Central Valley Gas Storage LLC  
3333 Warrenville Road  
Suite 300  
Lisle, IL 60532

April 24, 2015

Regarding: General Order 112-E Gas Audit of Central Valley Gas Storage Audit Letter  
(GI-2015-01-CVS39-01A and GI-2015-01-CVS39-15) issued March 26, 2015

Various flange bolt threads

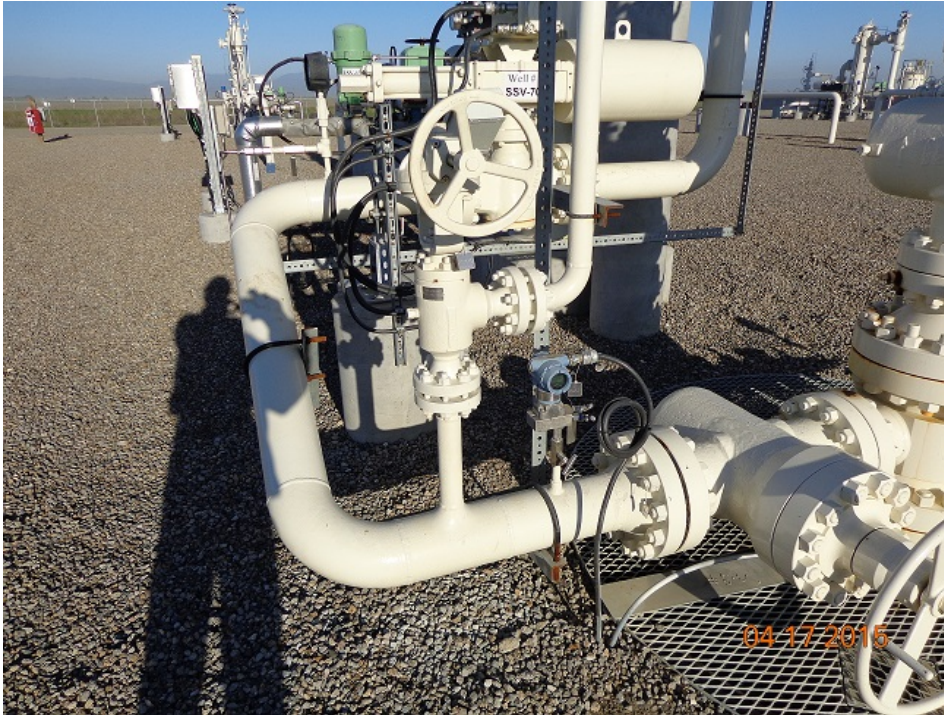
During the field visit on January 28, 2015 to the well pad, SED observed localized atmospheric corrosion at the following locations:

- a. Ball Valve 1251
- b. 1-L Scrubber Drain Valve
- c. 2-U Scrubber Drain Valve
- d. Various flange bolt threads

SED recommends CVGS address the areas of localized atmospheric corrosion to prevent further corrosion.

CVGS has applied additional coating to address the areas noted at the inspection. Please see updated photos of the observed locations as follows:
